BID ADDENDUM NO. 1
TO
CONTRACT DOCUMENTS
AND
TECHNICAL SPECIFICATIONS
FOR
POOL LOCKER ROOM RENOVATIONS
AT
HOMMOCKS MIDDLE SCHOOL
NYSED #66-07-01-03-0-011-031

Mamaroneck Union Free School District
1000 West Boston Post Road
Mamaroneck, NY 10543

LAN Job #4.1092.87
September 13, 2024

ENLARGED PROPOSED PLANS
POOL LOCKER ROOM RENOVATIONS AT
HOMMOCKS MIDDLE SCHOOL
130 HOMMOCKS ROAD
LARCHMONT, NY 10538
Job No. 4.1092.87
File No. 4109287A701
A7.02

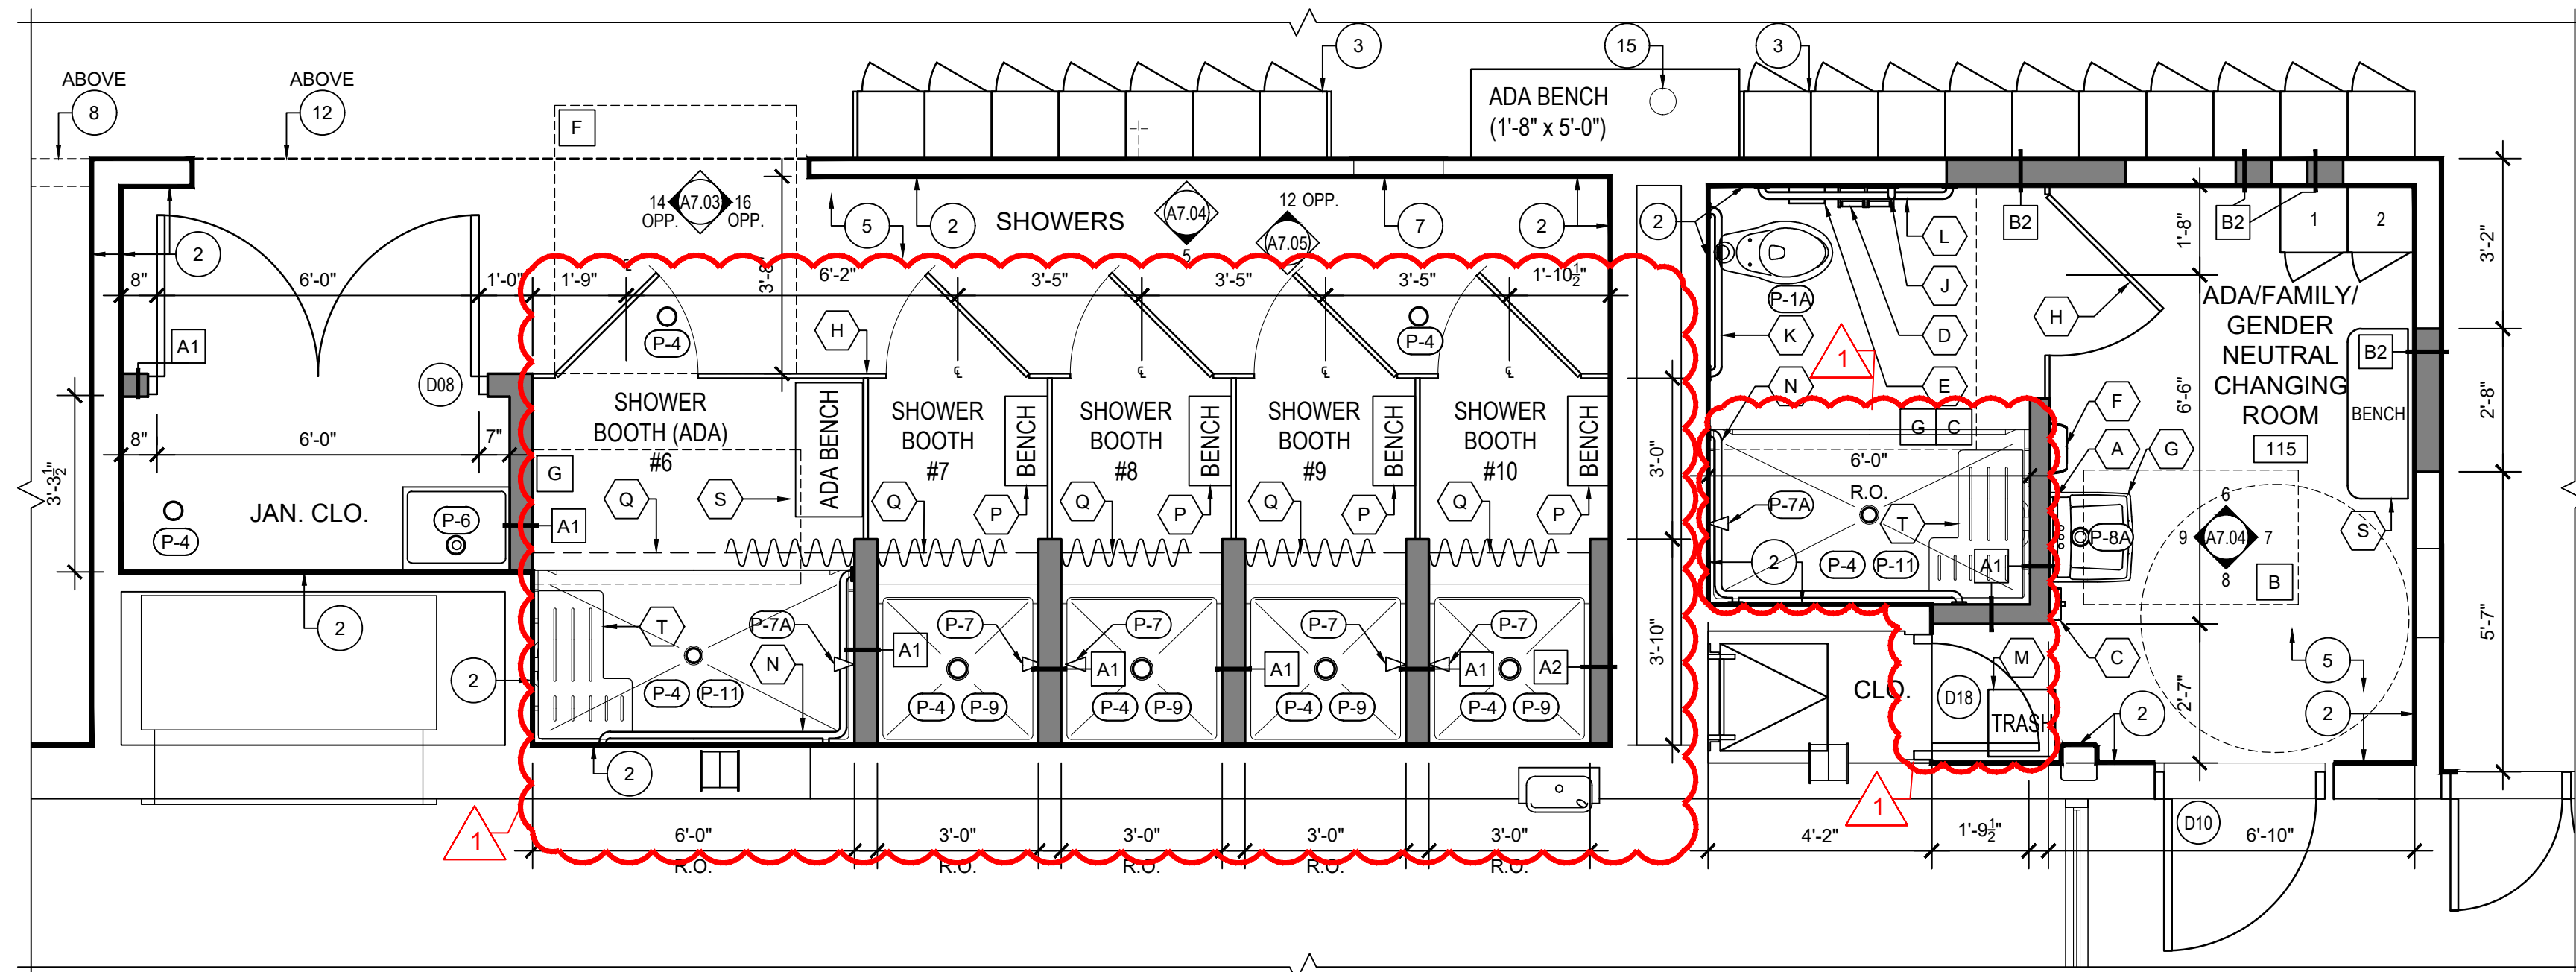
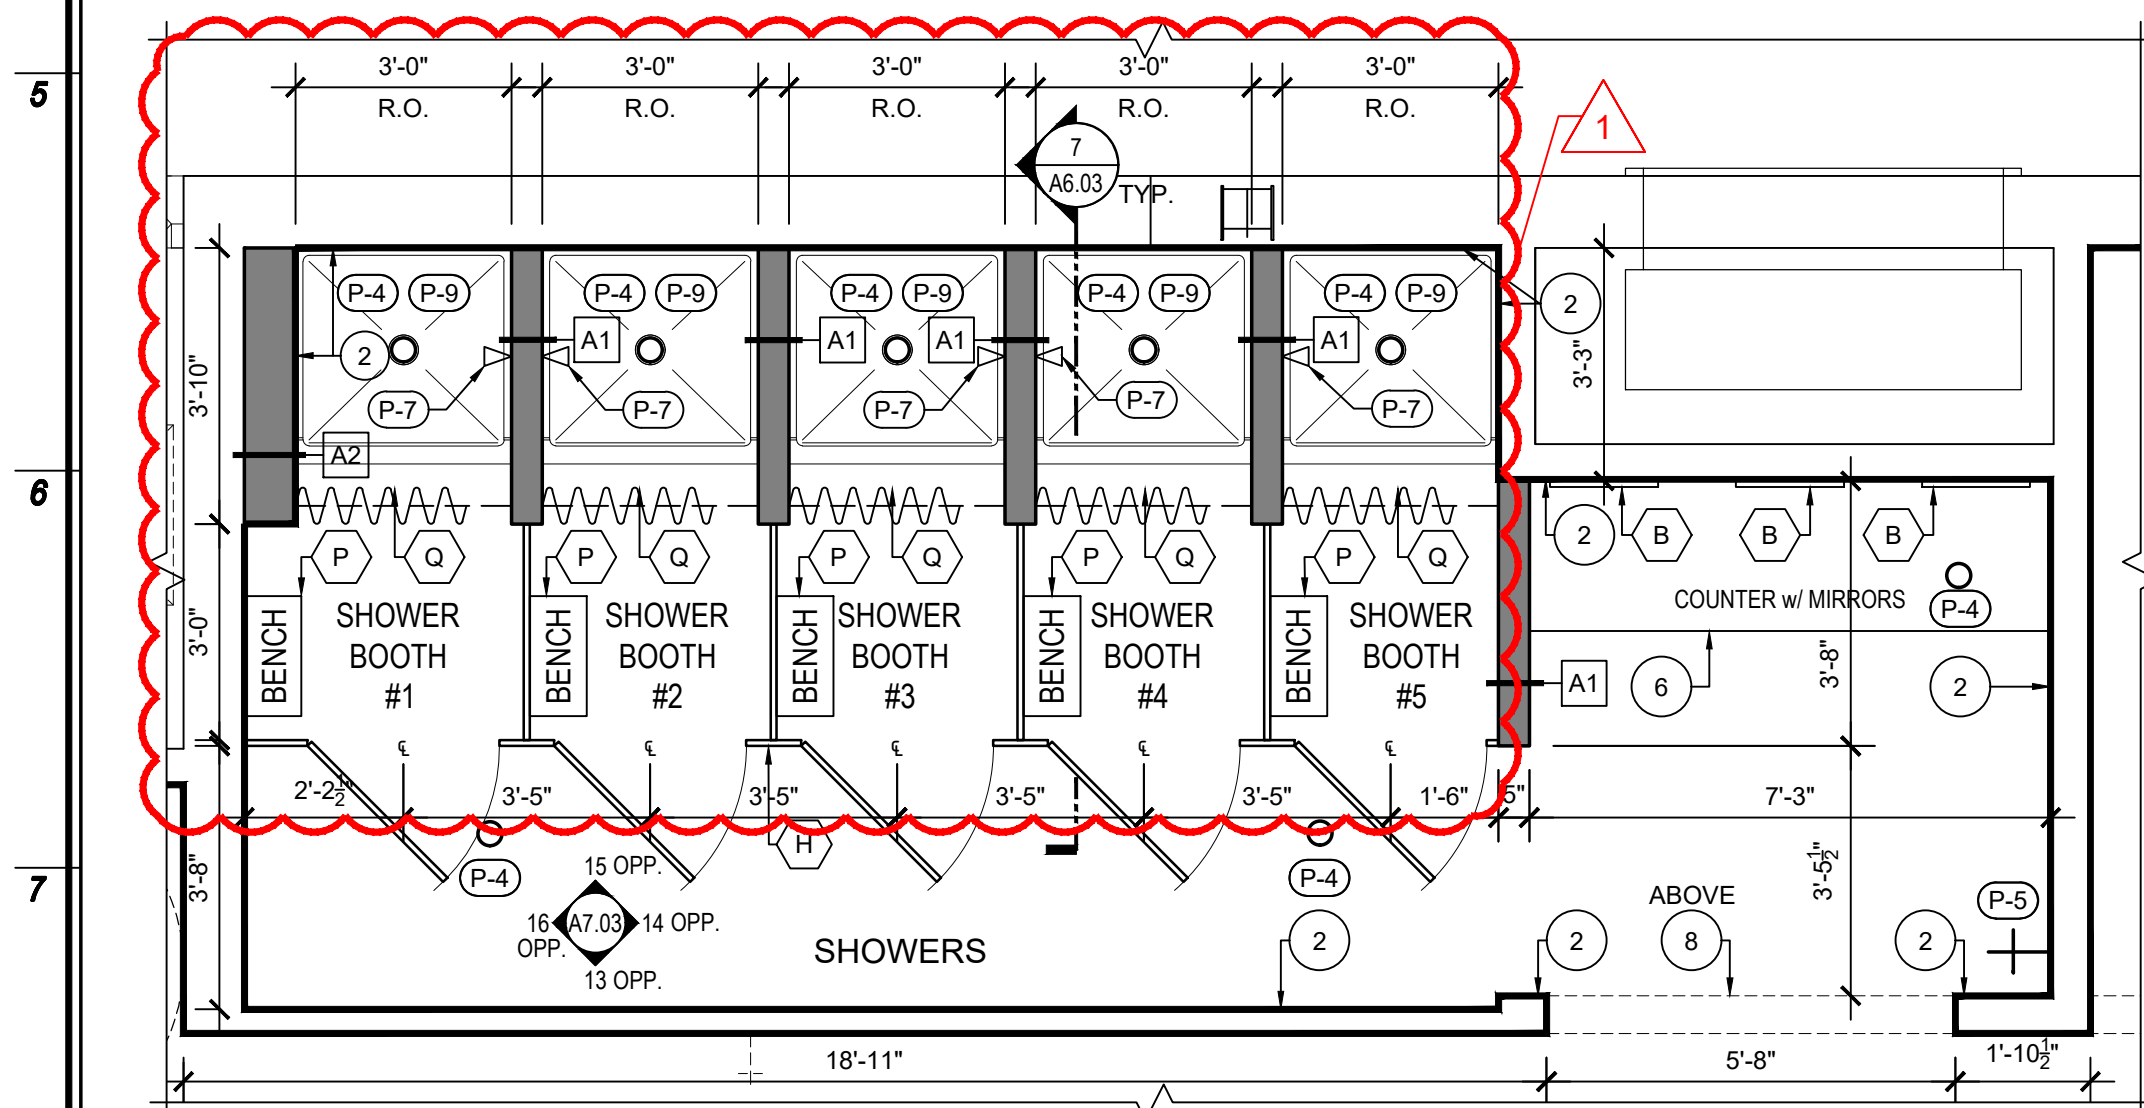
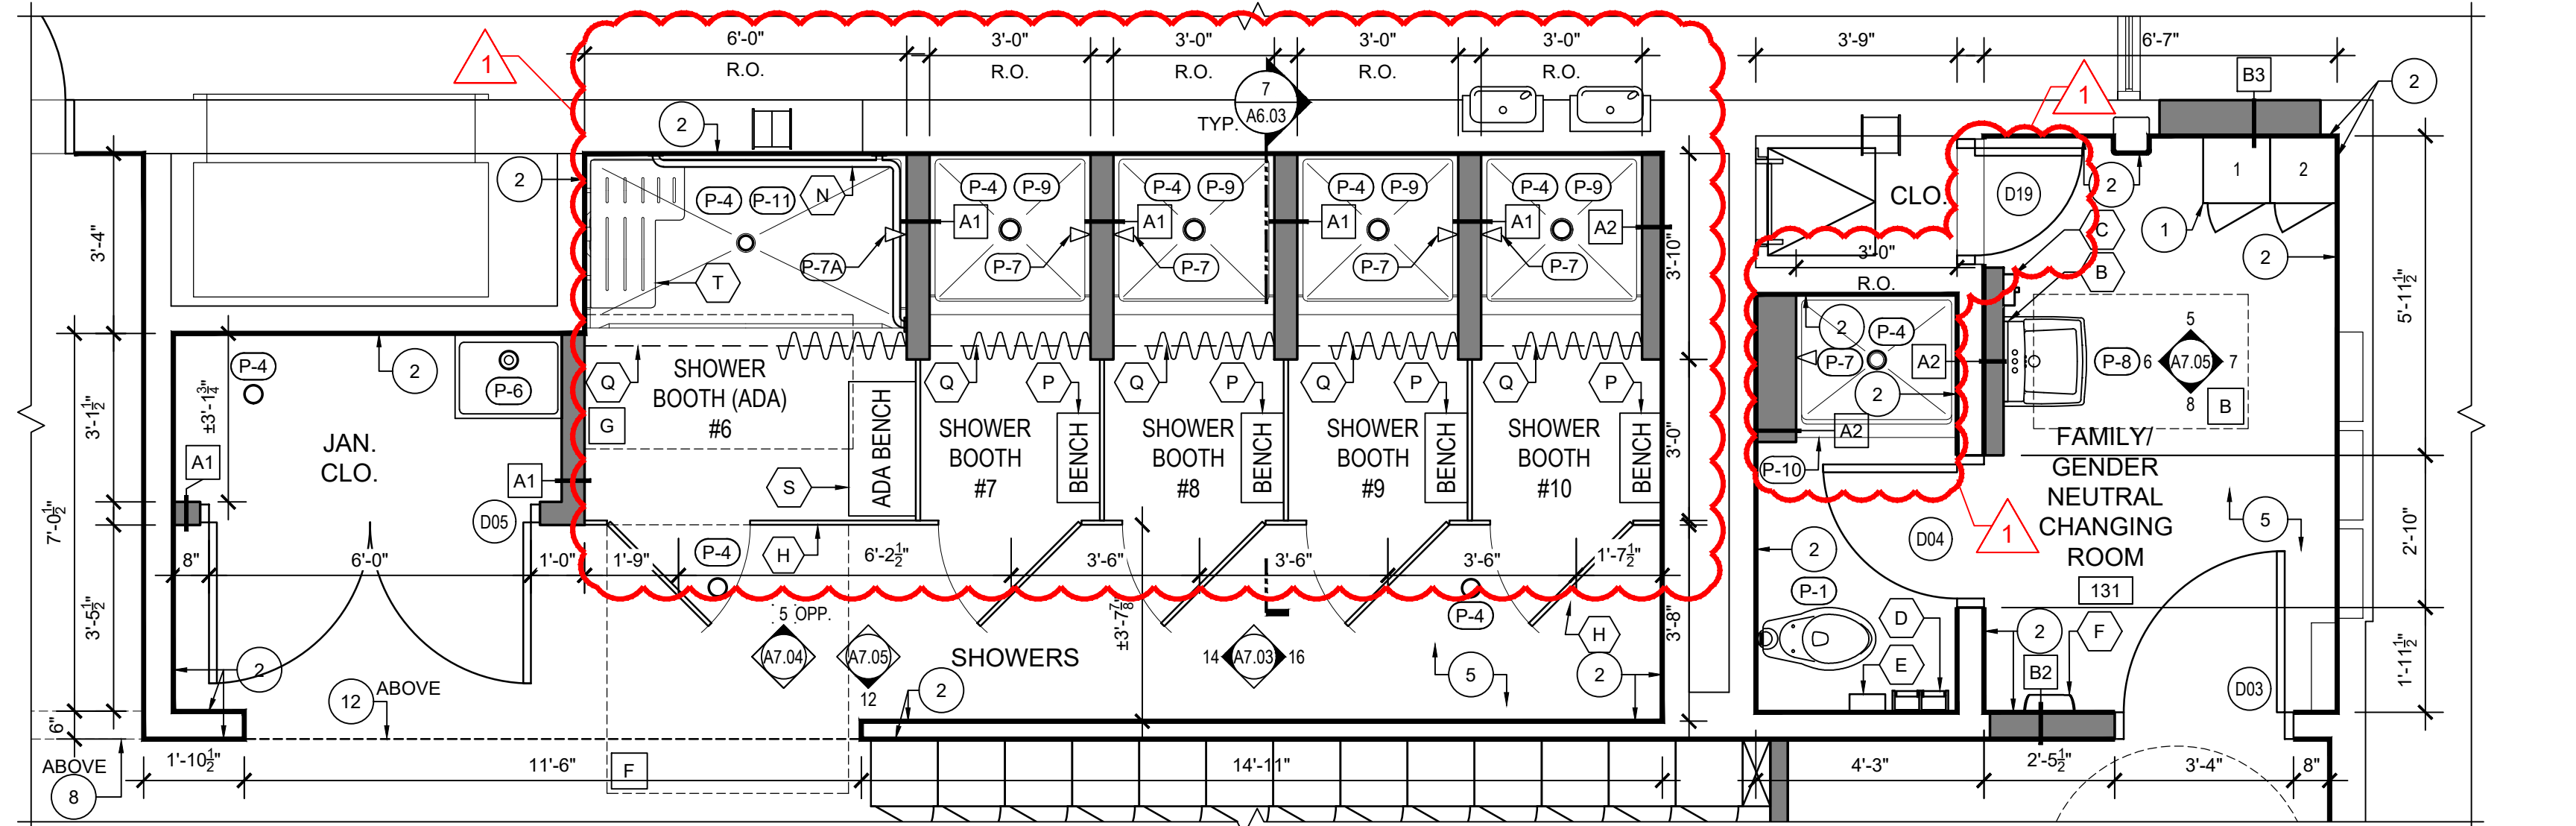
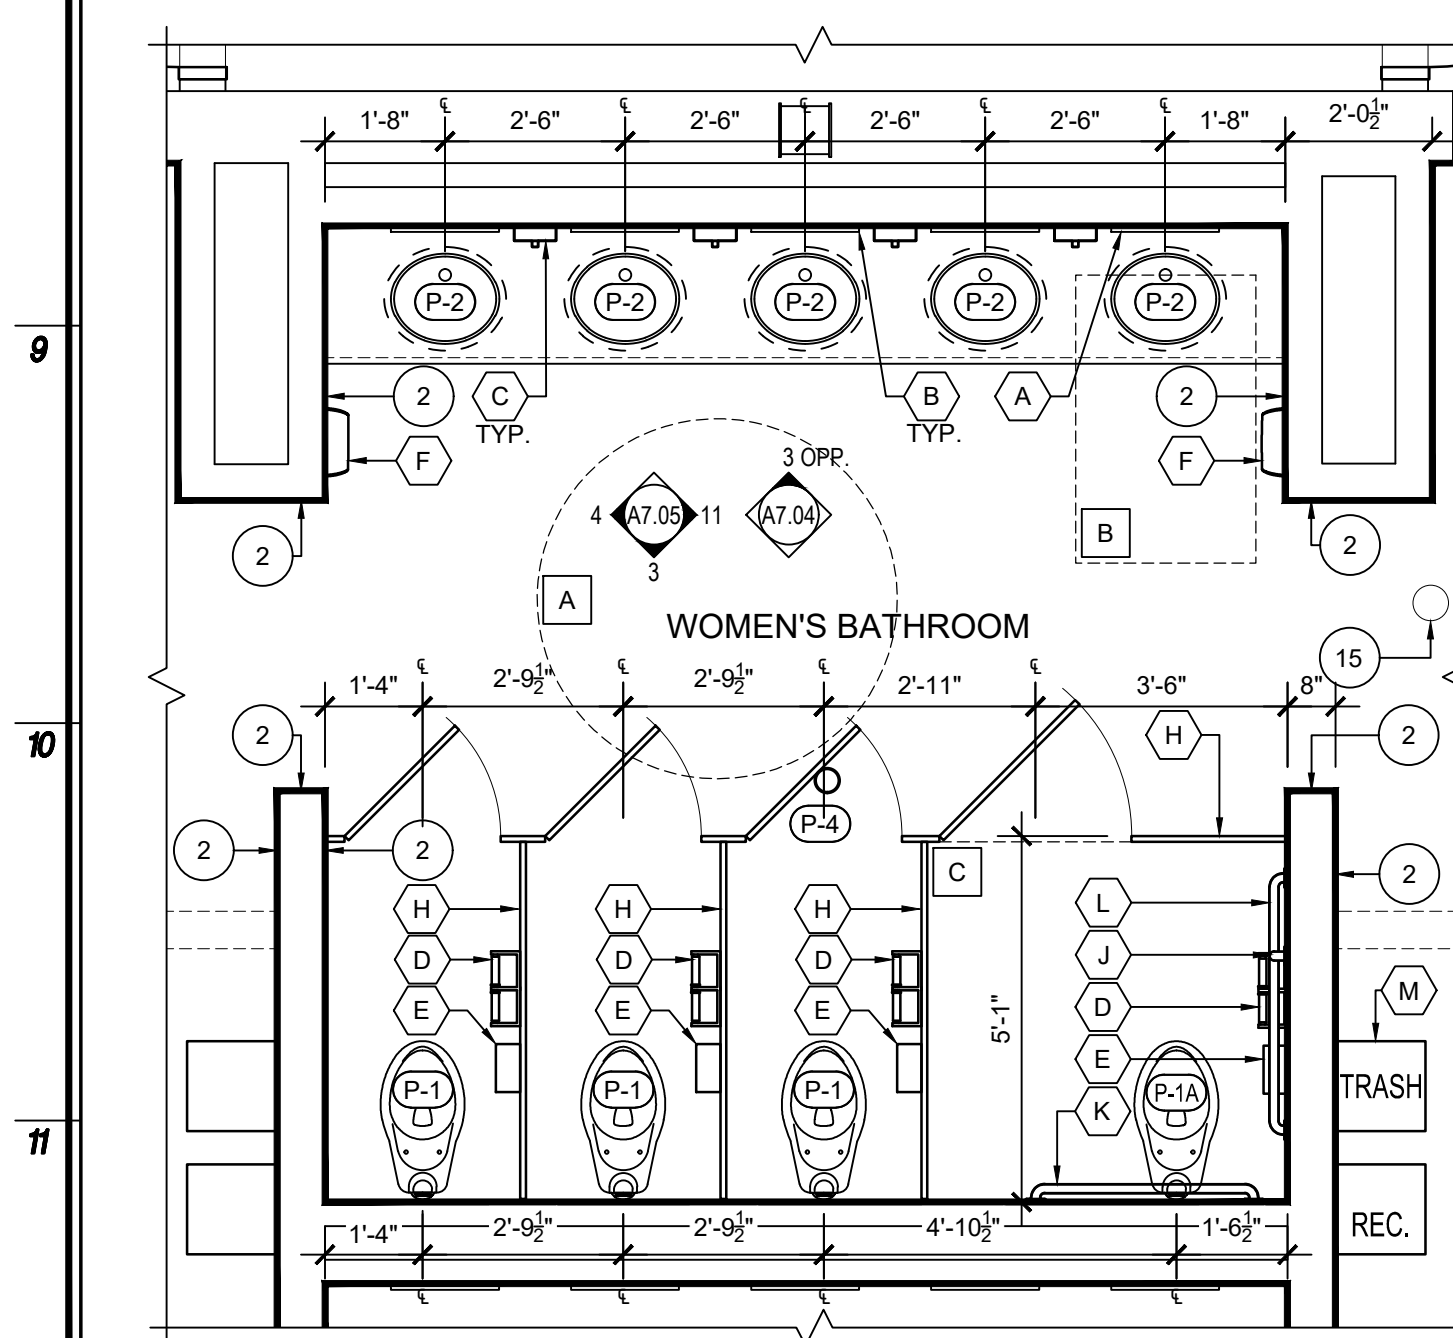
A7.02	<p><u>Drawing A7.02:</u> The following doors have been revised to be replaced with new: the corridor door accessing the men's locker room, the storage room door in the men's locker room, and the closet doors in the ADA/Family/Gender Neutral Changing Room 115 and Family/Gender Neutral Changing Room 131.</p> <p><u>Drawing A7.02:</u> The revision includes changes to the plumbing fixture tags for the new shower pans.</p>
